**VILLAGE OF KIMBERLY, WI**  
**NOTICE OF VILLAGE PLAN COMMISSION MEETING**

## Village of Kimberly Request for Plan Commission Recommendation

**ITEM DESCRIPTION:** Site & Architectural Review – Rebman Plumbing located at 700 W Kimberly Avenue

**From:** [Brad Werner](#)  
**To:** [Sam Schroeder](#)  
**Cc:** [Aaron J. Breitenfeldt](#); [Danielle Block](#); [Anna Huber](#)  
**Subject:** Rebman Plumbing 100 W Kimberly Ave Redevelopment Plan Review  
**Date:** Friday, December 6, 2024 11:47:38 AM  
**Attachments:** [image001.gif](#)  
[REBMAN PLUMBING 100 W KIMBERLY AVE.pdf](#)

File: P:\A\2024\65380010\65380010.dwg  
 Plot Date: Dec 23, 2024 11:33:00am  
 LAYOUT: GRADING

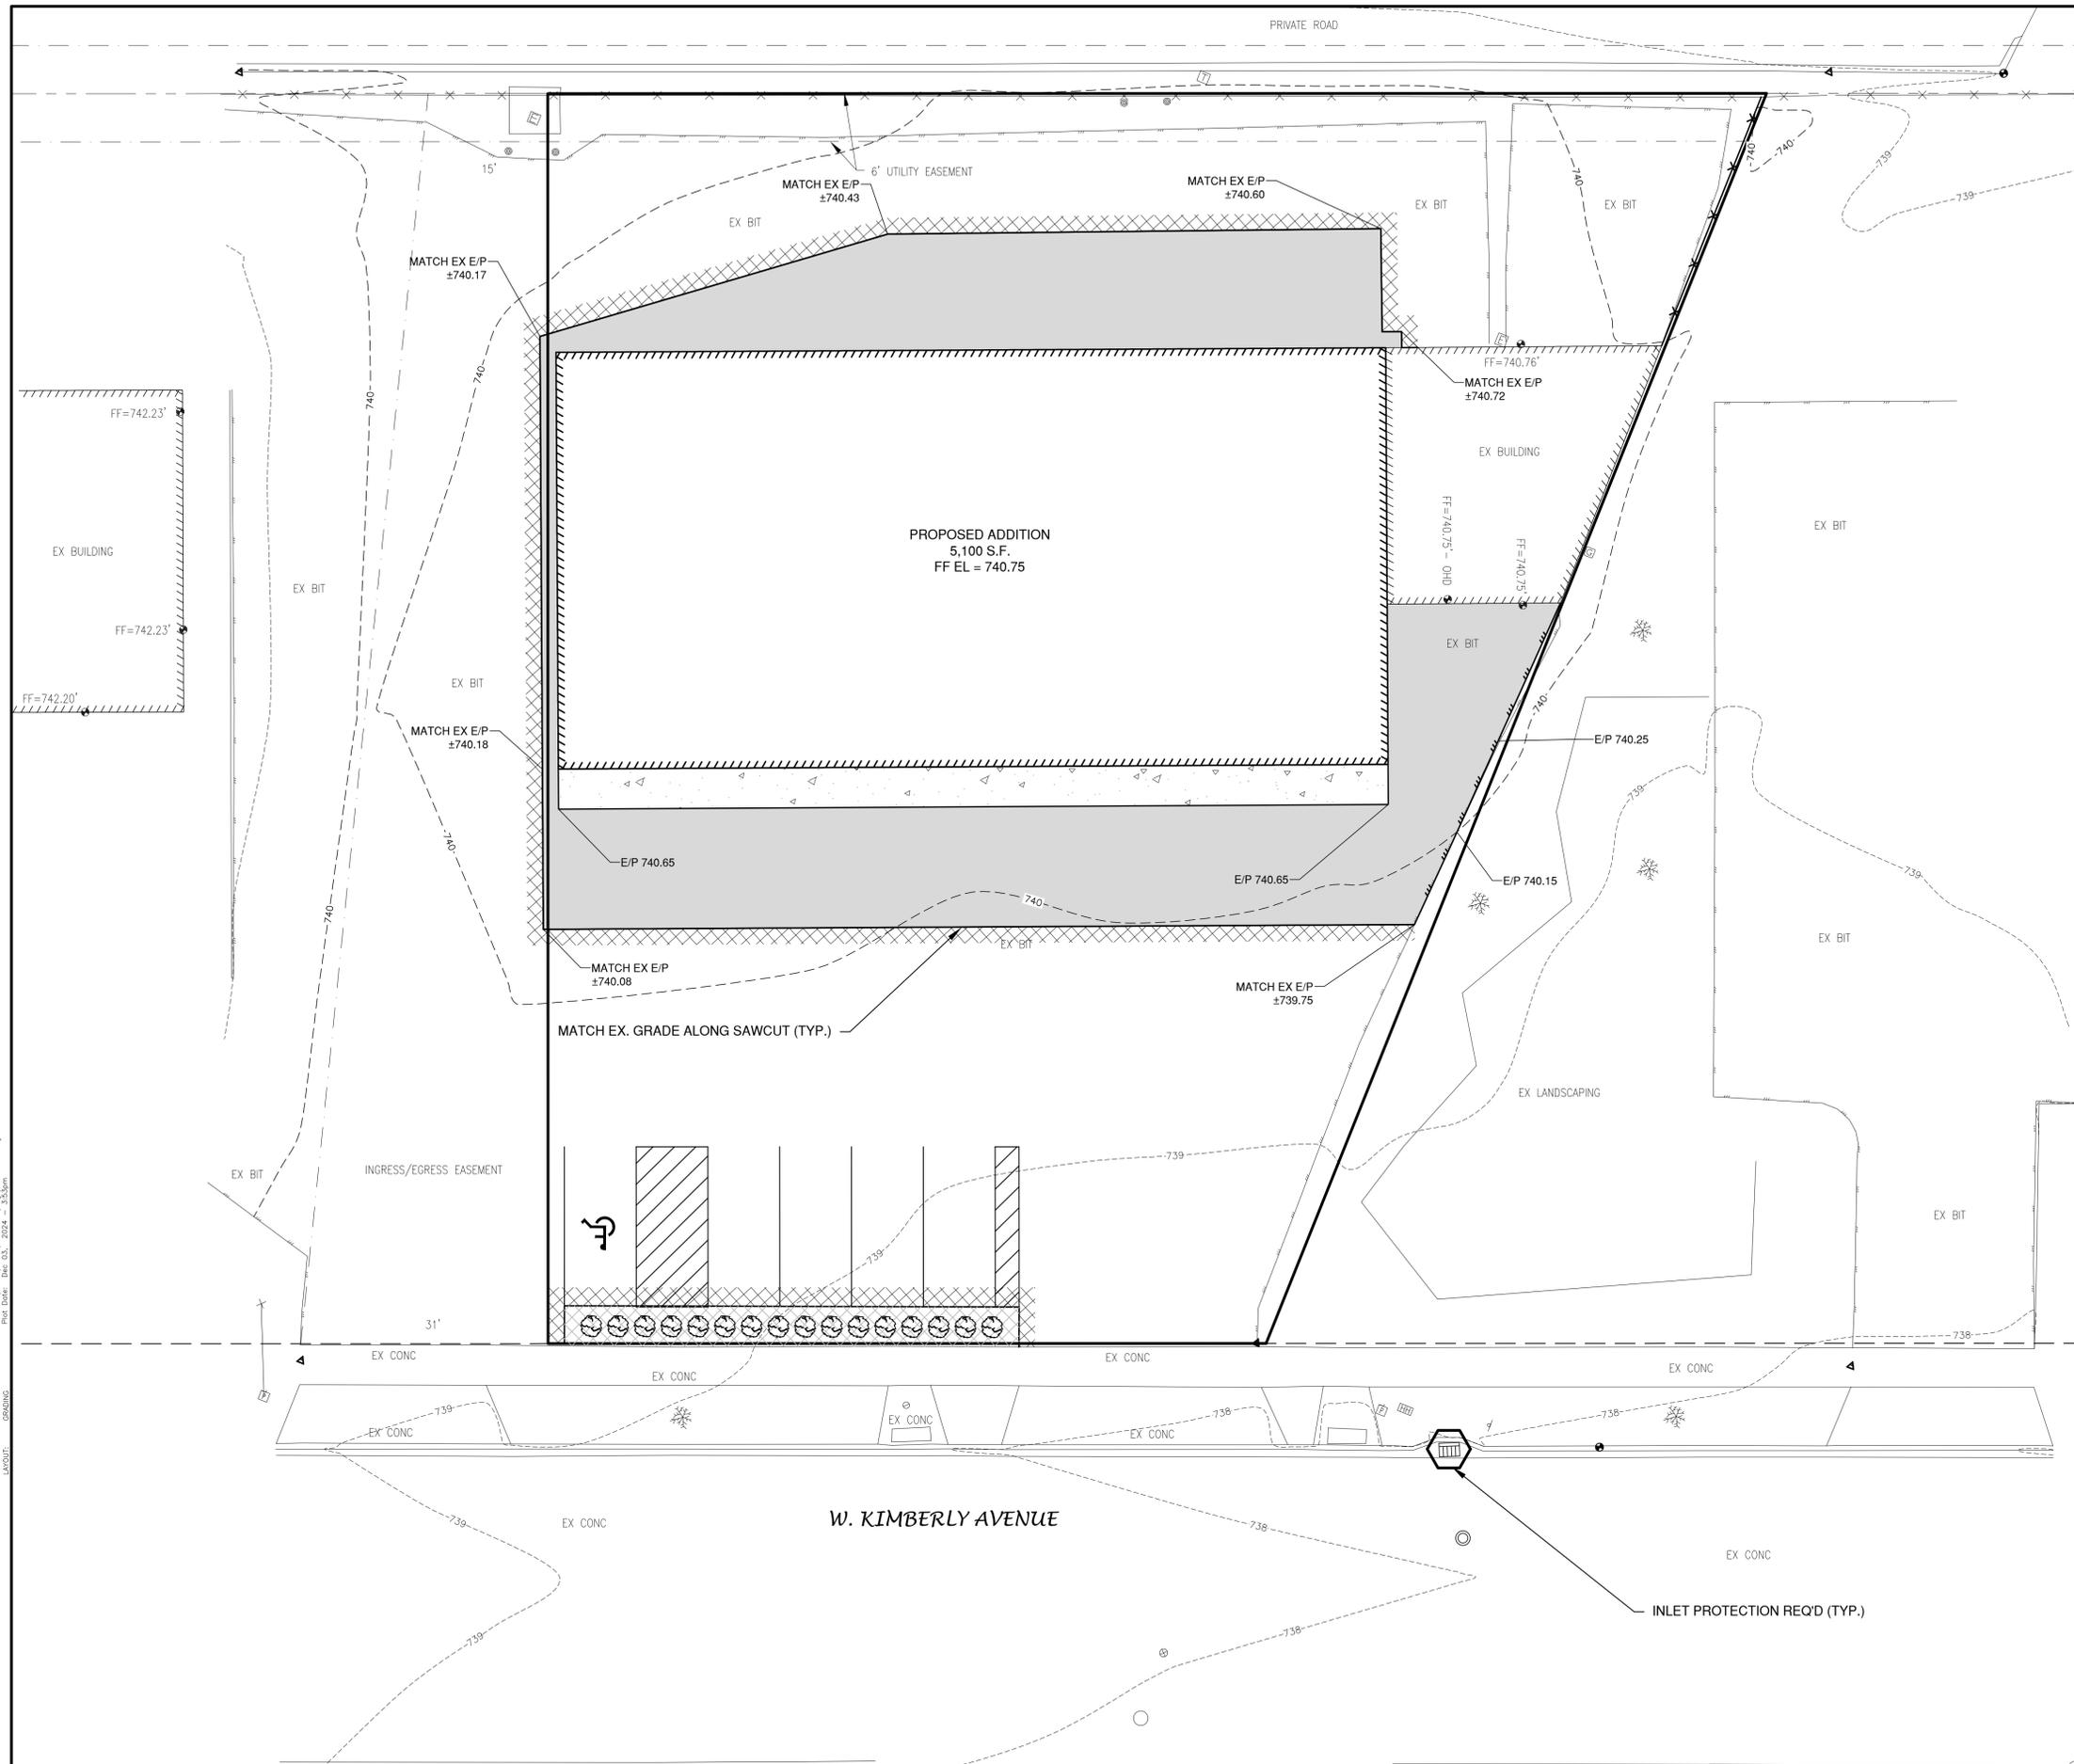
2. Site drainage has been a concern in the past in this location. There is no drainage plan for this lot and water currently sheds to neighboring properties and not directly to village owned collection systems. As we discussed with the owner and their engineer, this situation requires rectification. It is recommended that the owner install a collection system for storm water. This would most simply be done by connecting to the back of the inlet just east of their driveway opening on Kimberly Ave to connect to the Village system. A line can be extended into the property to allow for collection of surface water. An inlet can be installed on the east side of the driveway entrance as shown on my markup of their site plan. Either a curb head or small containment Berm or swale could collect water along the east property line and collect the surface water north of the Kimberly Ave sidewalk. In addition, it would be wise to collect roof runoff so that this major source of runoff can be properly directed to the storm sewer. The area north of the building drains onto private property and should also be collected and not discharged onto Bluebird Lane (a private drive lane).

3. The proposed building is higher than the paved area to the west by what appears to be 6 inches. The property to the west has an ingress / egress easement provided by that property owner. How will the transition be handled and does the transition encroach the neighboring property? Has the neighbor seen and plan and are they aware that the plans show a disturbance and grade change on their property?

EXISTING SITE CONDITIONS

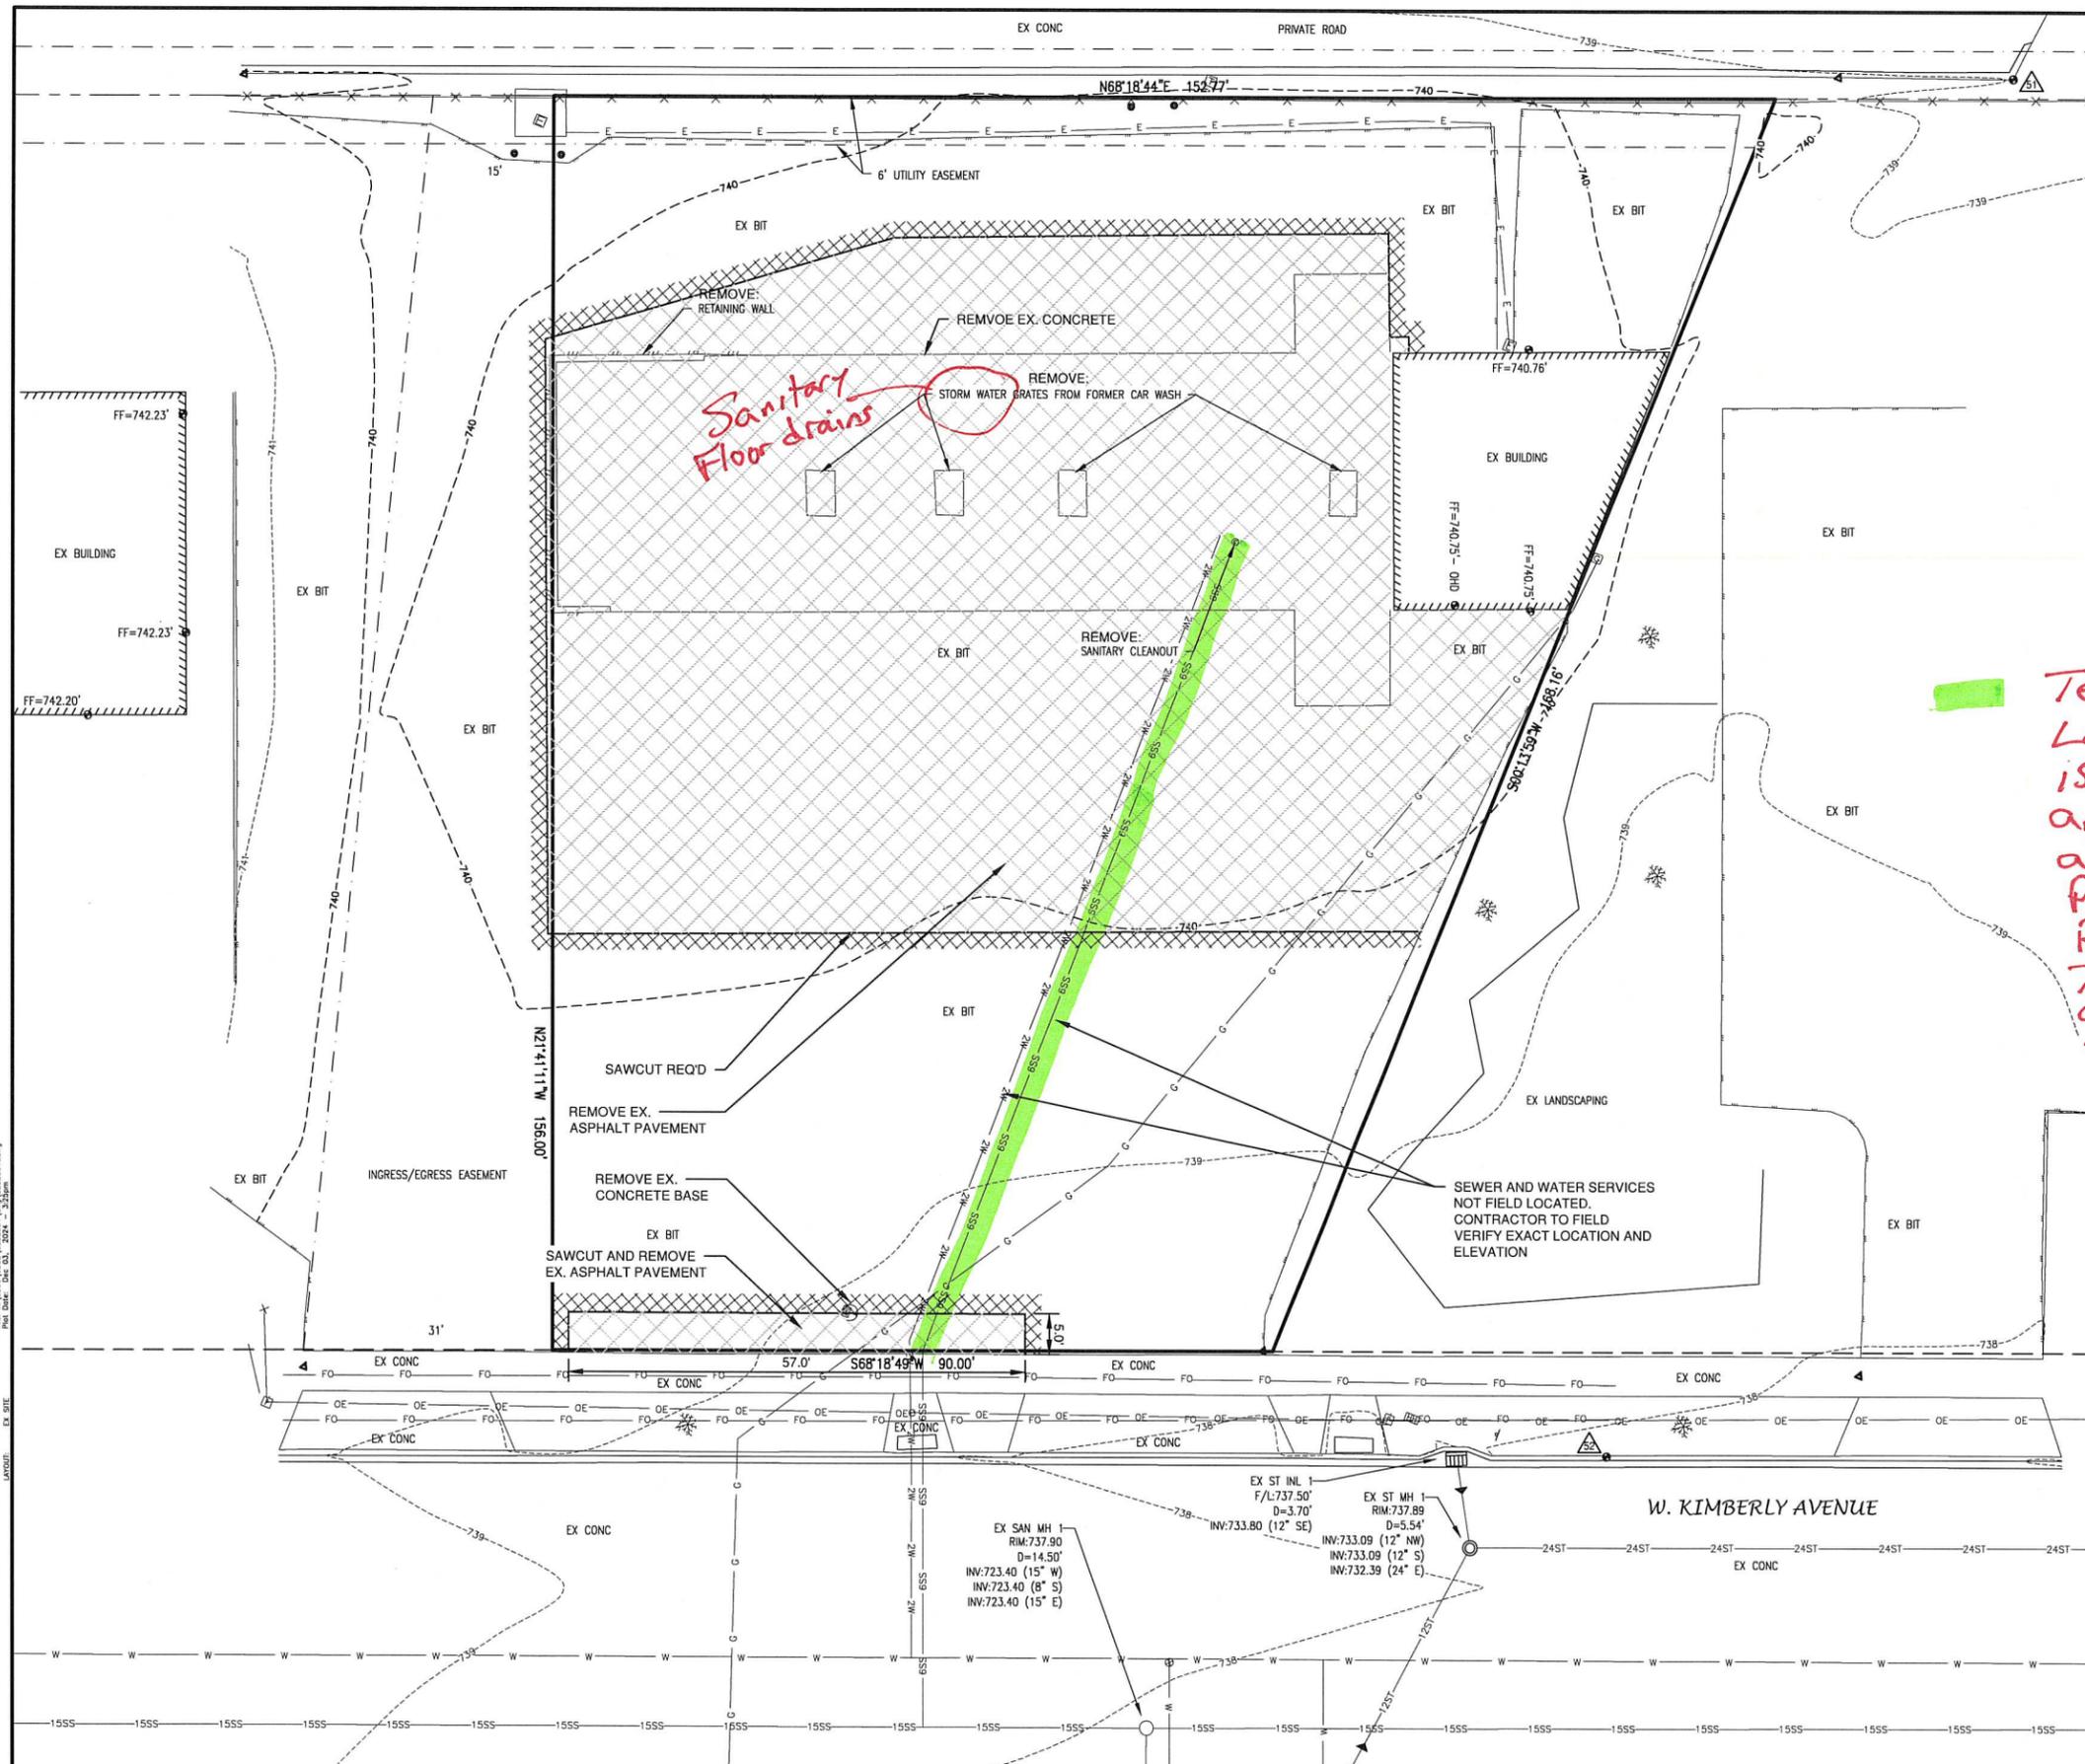
4. The site plan notes existing storm drains, however, these would have been sanitary drains for the car wash bays. These are required to be completely disconnected from the sanitary line. Our records from the 2015 sanitary and water relay on Kimberly Ave indicate the lateral connection to the existing on private property was to a 6 inch sch 35 PVC line. This line would be material compliant with our ordinance. I would recommend a final televising of this line be done and provided to the Village to demonstrate that the post constructed line is fully intact and that all connections are for the new improvements only.

*Televise Existing Sanitary Lateral to confirm there is no clearwater entering and no wyes from abandoned floor drains. Provide Televising and Report to Village. Televising can be completed after modifications to the line have been completed per Engineer's note on Sheet 4.*
